Access Compliance Report

Public Rights-of-Way

(Curb Ramps)

Intersection ID: 24385	Main Street: BEVERLY_CREST_BV	Cross Street: BECKMORE_PL	Location: SE
ADA ID: 10F964F1AED5	Ramp Type: Perp	Initial Pass/Fail: Fail	Overall Compliance: No
Severity Score: 12.5			
Codes/Mitigation Info/Possible Solution		Field Measurements/Component Compliance

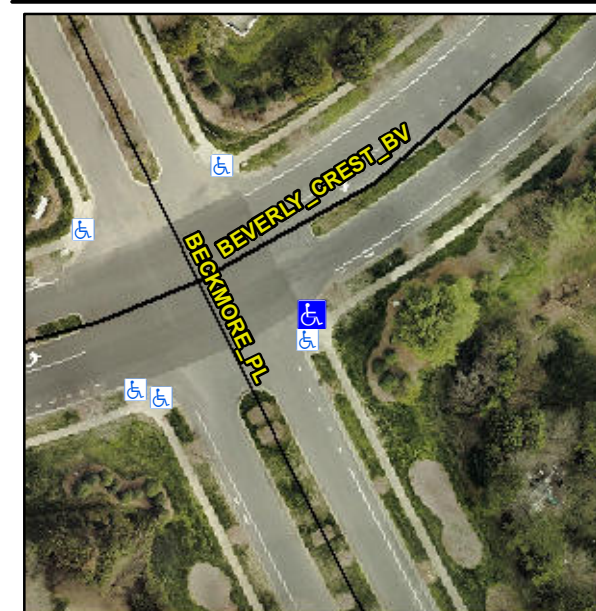
Not Found, R304.2.2

Compliance	Description	Data	Compliance	Description	Data
N/A	Ramp Length (in)	96.0	No	Ramp Slope (%)	9.0
Yes	Ramp Width (in)	62.0	Yes	Ramp XSlope (%)	1.9
N/A	Flare Type LT	N/A	N/A	Flare Type RT	N/A
N/A	Flare Slope LT (%)	N/A	N/A	Flare Slope RT (%)	N/A
N/A	Flare Traversable LT?	N/A	N/A	Flare Traversable RT?	N/A
N/A	Landing Length (in)	N/A	N/A	DWS Provided?	N/A
N/A	Landing Width (in)	N/A	N/A	DWS Contrast?	N/A
N/A	Landing Slope (%)	N/A	N/A	DWS Length (in)	N/A
N/A	Landing X Slope (%)	N/A	N/A	DWS Full Width?	N/A
N/A	Landing Curb? (Y/N)	N/A	N/A	DWS Offset (in)	N/A
N/A	Shared Landing?	N/A			
N/A	Gutter Ponding?	N/A	N/A	Gutter Slope (%)	N/A
N/A	Gutter Lip Ht (in)	N/A	N/A	Gutter X Slope (%)	N/A
N/A	Painted X Walk1?	No	N/A	Painted X Walk2?	N/A
	X Walk 1 Direction	To N		X Walk 2 Direction	N/A
N/A	X Walk 1 Width (in)	N/A	N/A	X Walk 2 Width (in)	N/A
	X Walk 1 Slope (%)	0.4		X Walk 2 Slope (%)	N/A
	X Walk 1 X Slope (%)	2.8		X Walk 2 X Slope (%)	N/A

Remove & Replace Entire Ramp.
